SITE PLAN REVIEW AND APPEARANCE BOARD STAFF REPORT

1236 George Bush Blvd.

Meeting	File No.	Application Type
May 25, 2022	2022-014-SPF-SPR-CL5	Class V Site Plan Modification
Property Owner	Applicant	Agent
1236 George Bush Blvd LLC	1236 George Bush Blvd LLC	Thomas F Carney Jr.

Consideration of a Class V Site Plan, Landscape Plan, and Architectural Elevations for a proposed 6-unit townhome development located at 1236 George Bush Blvd.

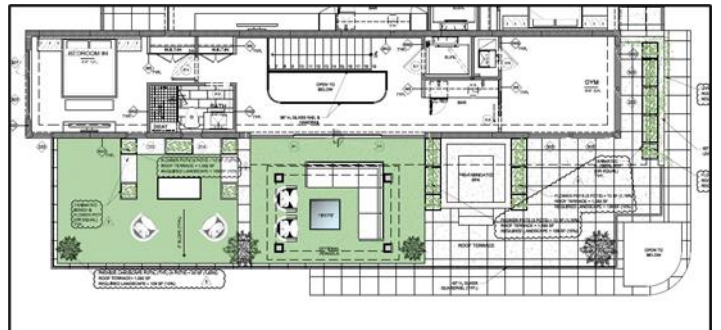
Rooftop landscaping is proposed. Pursuant to **LDR Section 4.3.3(RR)(3)(C)** Rooftop use areas greater than 100 square feet and located below the maximum building height shall landscape a minimum of ten percent of the rooftop use area. Rooftop use areas that are located at the maximum building height shall landscape a minimum of 20 percent. Landscaping shall consist of trees, shrubs, ground cover, and vines.

Roof top terraces are provided on the second floor, and are 1,092 SF. The applicant has provided 109 SF of landscaping, which includes living walls, planters, and pots (see the figure to the right).
